JINDAL ALUMINIUM LTD.
BANGALORE-560073 (INDIA)

NAME	DATE
DRAWN	PARVESH	19-10-2013
CHECKED		
APPROVED	S.S.GARG	19-10-2013
SCALE		0.5:1
AREA mm ²		1286.113
PERIMETER mm.		499.813
WEIGHT kg/m		3.473
DRAWING No.	SECTION No.	
P-12318	-	
10433	10433(ISSUE-3)

PARTY'S NAME	BANGALORE MARKET (ROLLING MILL DIVISION)
PARTY'S DRAWING No.	AS PER SPECIFICATION
ALLOY & TEMPER	19700
DESCRIPTION	FLAT BAR

P-12318

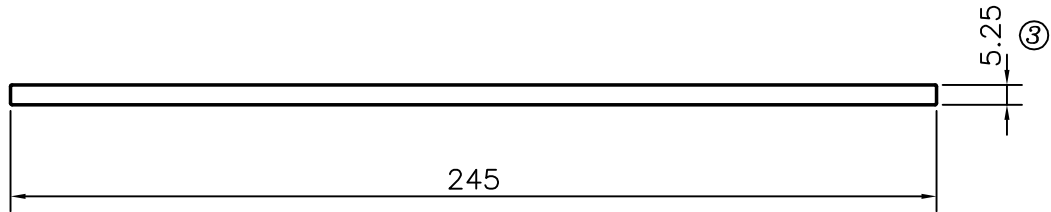
ISSUE (2) :-

☞ TOLERANCE ADDED ON THICKNESS.

ISSUE (3) :-

☞ THICKNESS CHANGED FROM 4.2 TO 5.25 mm.

☞ WEIGHT ALSO CHANGED FROM 2.778 Kg/M. TO 3.473 Kg/M.
